Re: Elisabeth & William Fedyna
Supplemental Materials
Harbor & Coastal Zone Management Commission Application
Consistency Review of Wetlands Permit Application
Premises: 1165 Greacen Point Road, Village of Mamaroneck, New York
(Parcel ID: 9-65 -75)

MEMORANDUM

RE: Site Plan Approval
Fedyna
1165 Greacen Point
Section 9, Block 50, Lot 373

Drawn: RAR Approved: JAR
Scale: 1" = 20'
Date: 06/08/2020
Project No: 18100
Title: EXISTING DRAINAGE AREA MAP
Drawing No: DA-1

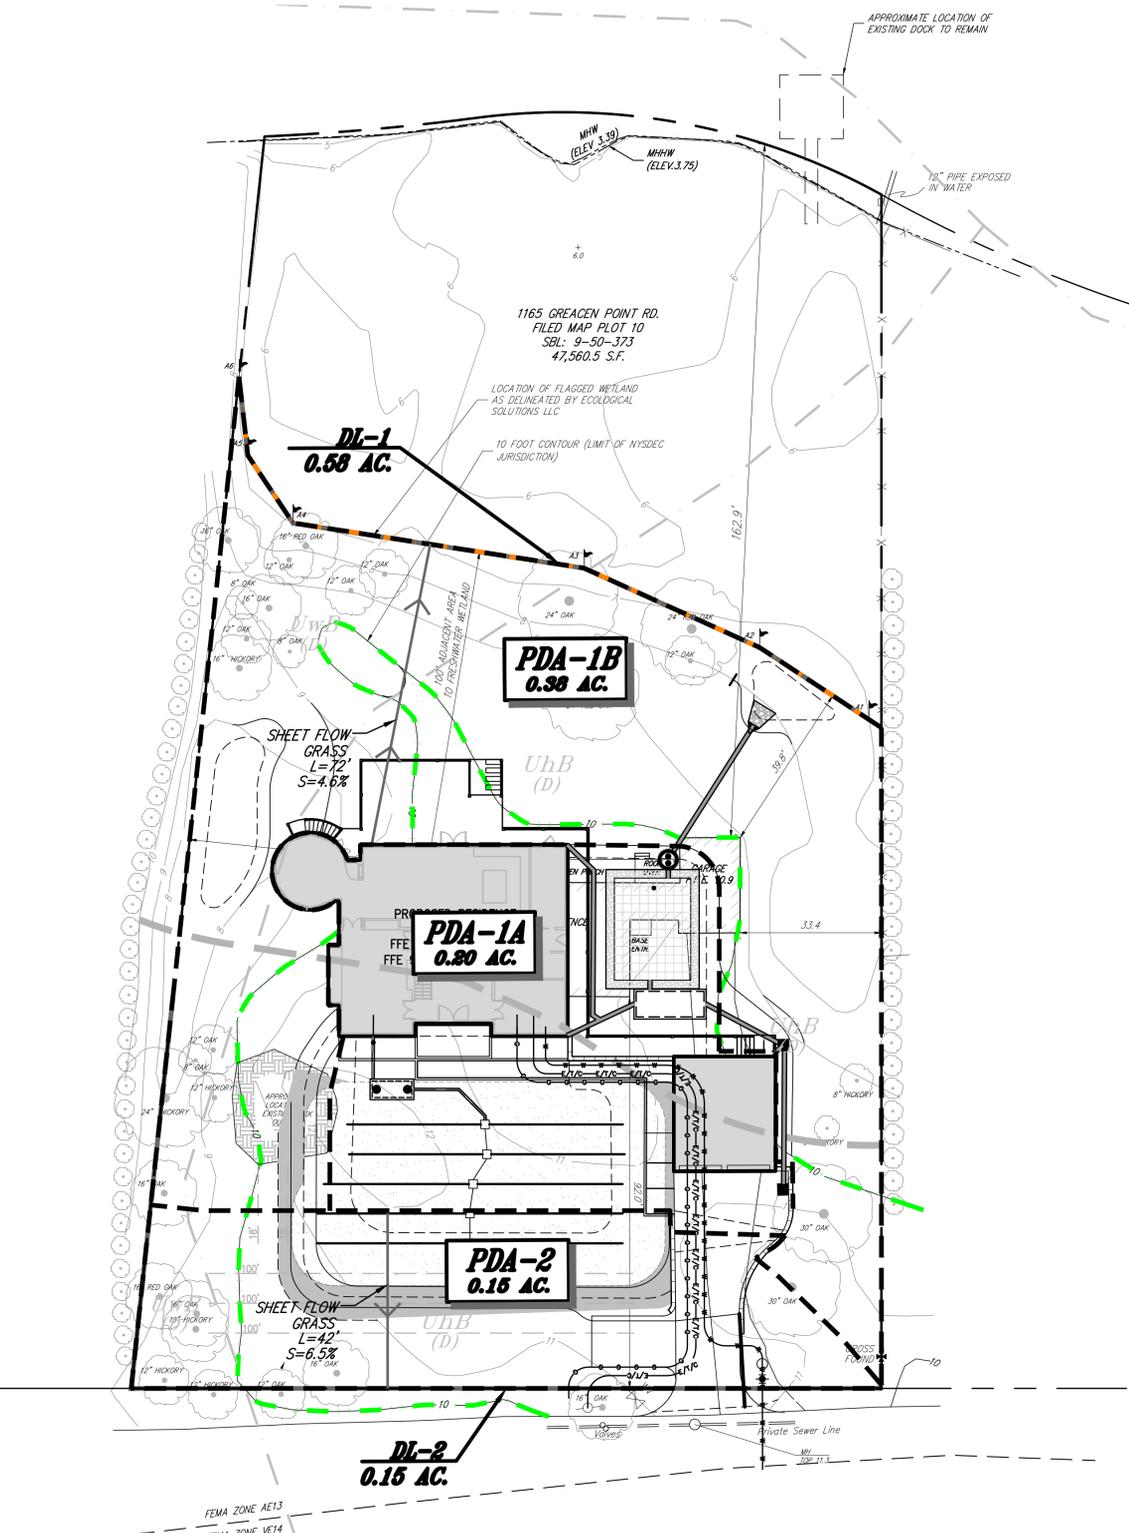
The Drainage Area maps were not included in the SWPPP submission. Please provide.
